To: Branch Smith, Paramounte Engineering
From: Pat O’Mahony, Associate Planner; 910-341-0189
CC: File;
Date: 10/6/2020
Re: College Acres Apartments TRC Rev. 1

Engineering has reviewed the plans for the College Acres Apartments project submitted September 2, 2020 for TRC review and have the following comments:

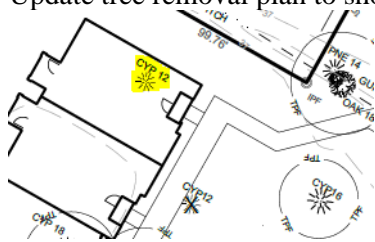
- Provide an open space diagram showing all areas included in the 35% required open space.
- Update tree removal plan to show 12” cypress being removed

C-4.0
PEI JOB# 19443.PE

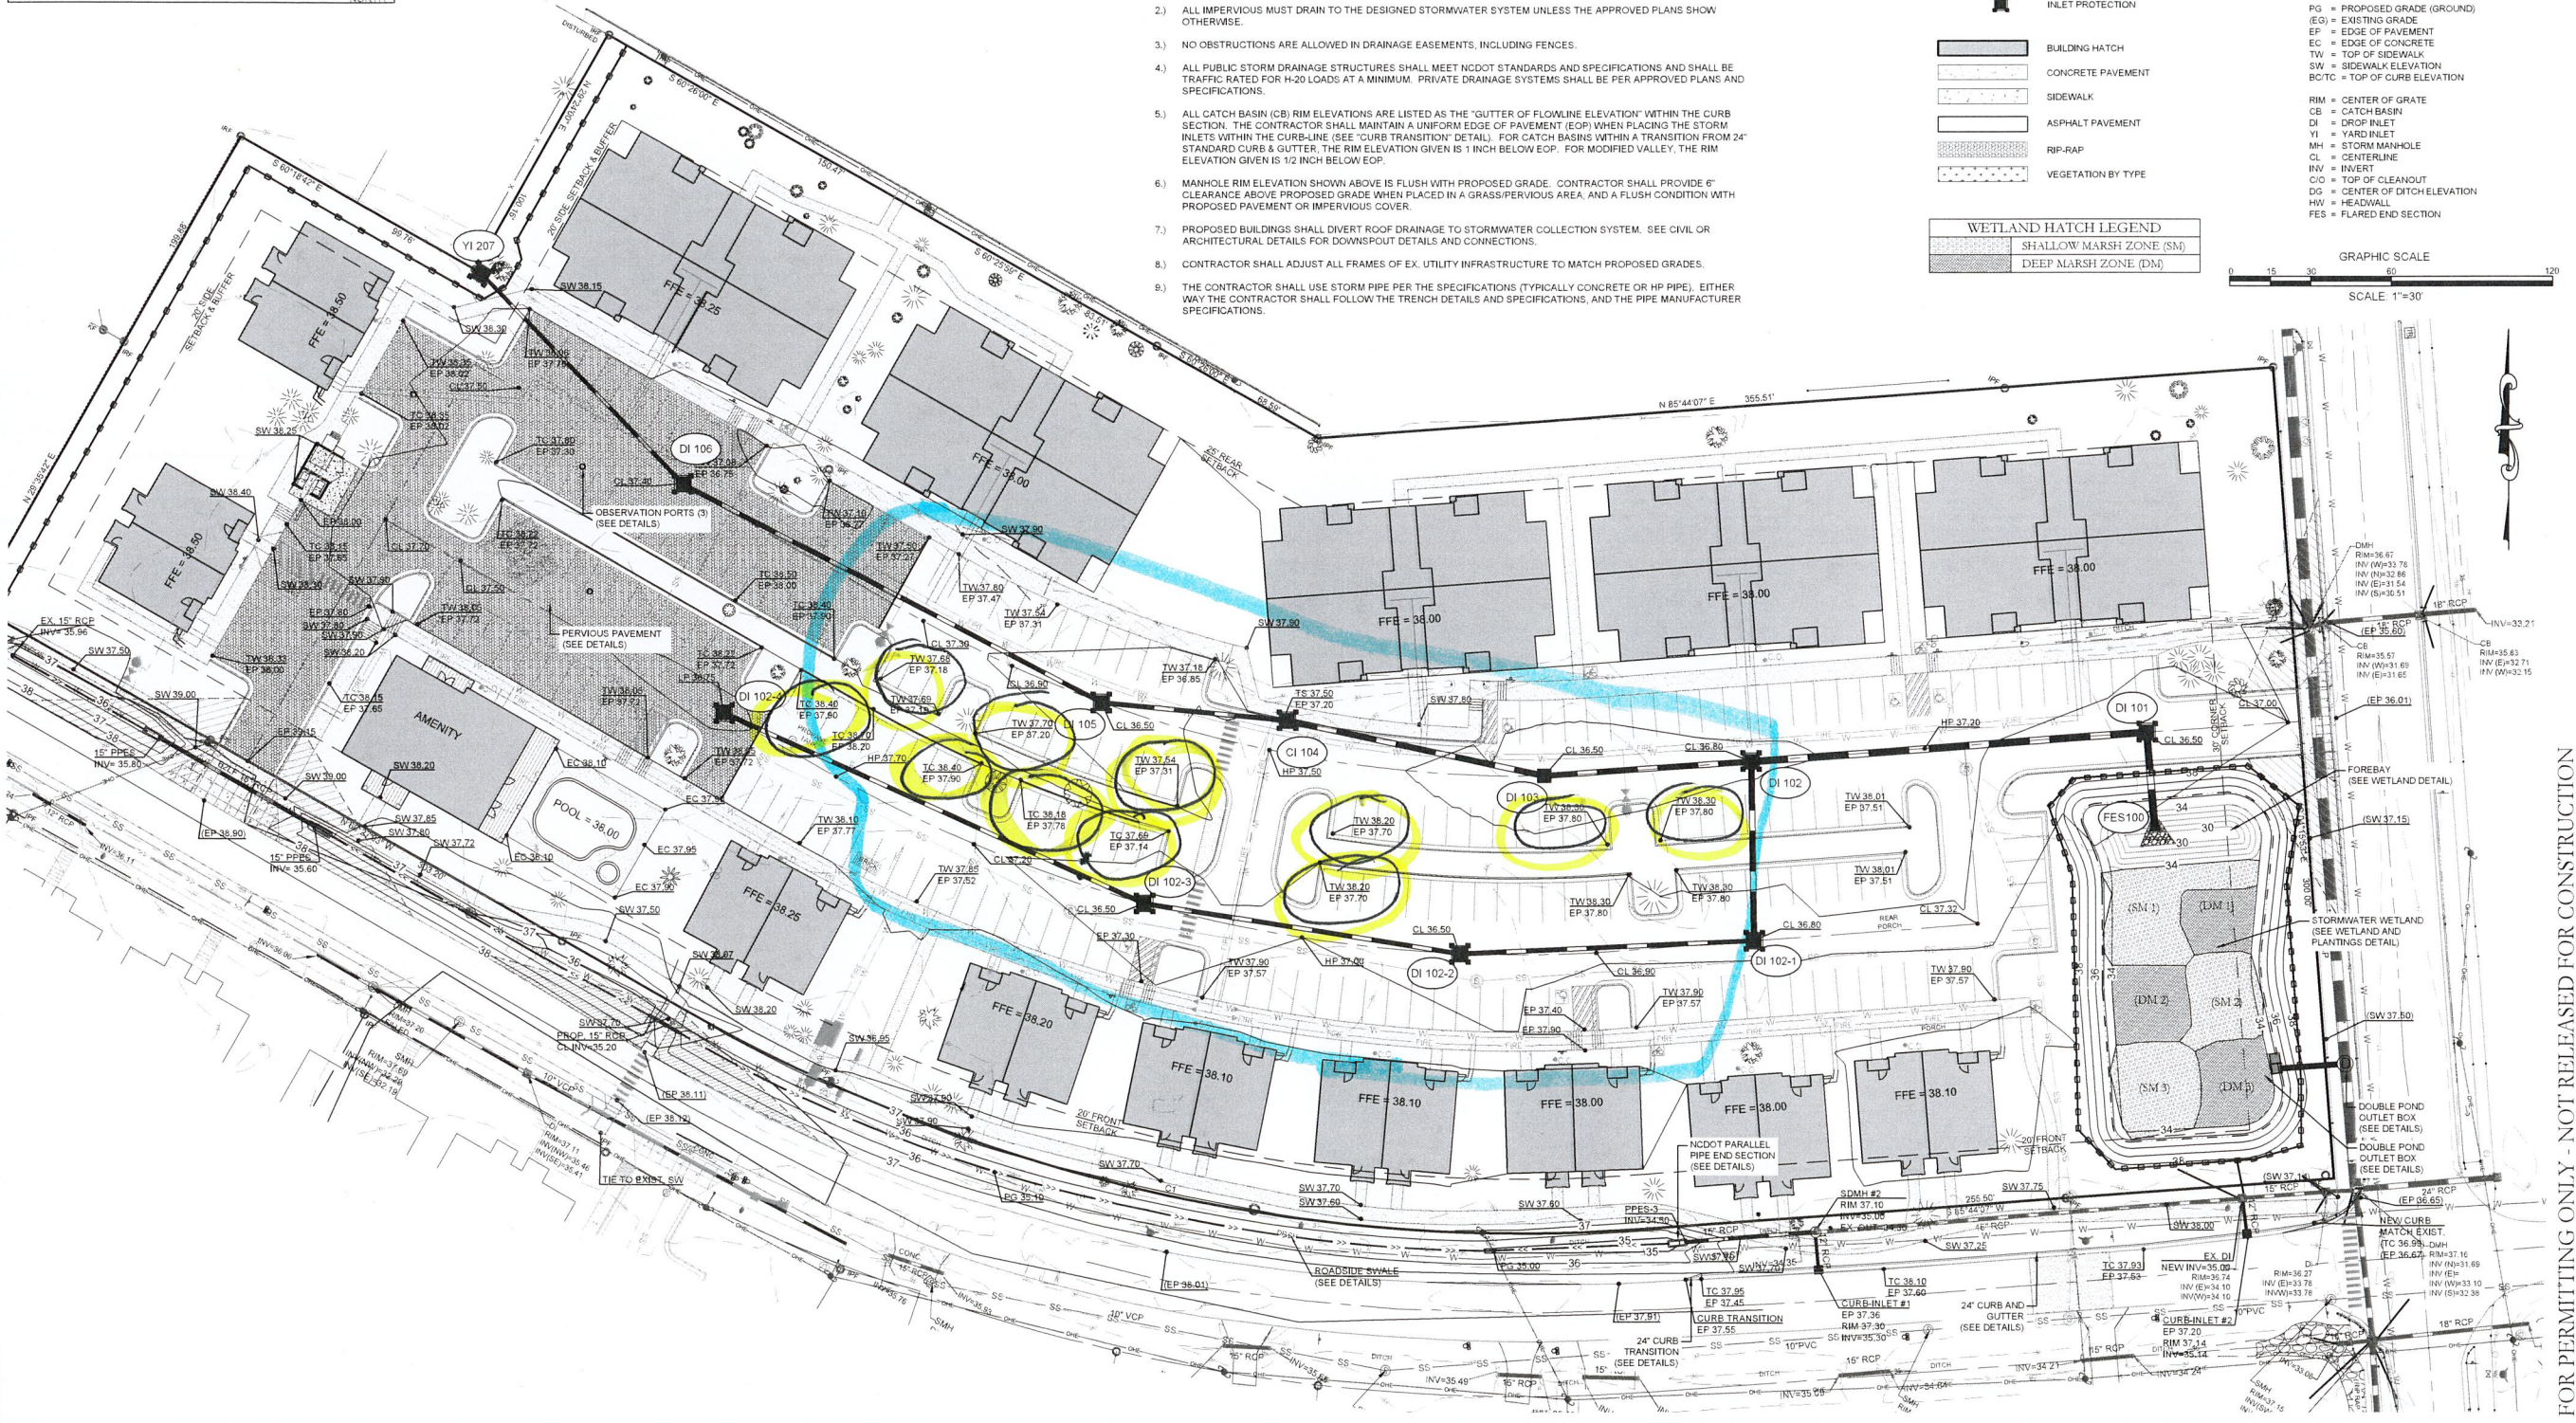
- b. The sidewalk along the northern side of the proposed amenity center is mislabeled as having curb and gutter (#1).
20. C-4.0:
- a. The western edge of the property has been left out. Adjust the viewport to see the entire site.

- b. All pipes in the r/w must have flared end sections or parallel end sections.
 - c. There appears to be some type of structure in the swale alignment in front of the amenity building.

- d. The EX DI near the intersection of College Acres and Racine is too close to the sidewalk. Move the sidewalk away from the inlet. There should be a 12-inch shoulder between the top of the slope and the sidewalk anytime the sidewalk is close to a swale. This situation appears to occur at the western end of College Acres Drive.

- e. Provide more details for screening roof runoff and the downspout collection systems. I need to understand where the screening will occur and how and where the screened runoff enters the PP. Are the downspouts to tie into the stone base of the PP? What and where are the emitters to be used? Emitters may not be able to be used depending on their location.

- f. Show and label the header curb between the asphalt and PP.
 - g. The stormwater wetland does not appear to have the proper zones as outlined in the design manual. A stormwater wetland must have a forebay, non-forebay deep pools, temporary inundation zones and a shallow water zone (See Figure 1 and 2 in the SW section of the design manual). The forebay appears to be too large. There is no non-forebay deep pools or inundation zone shown in your design.
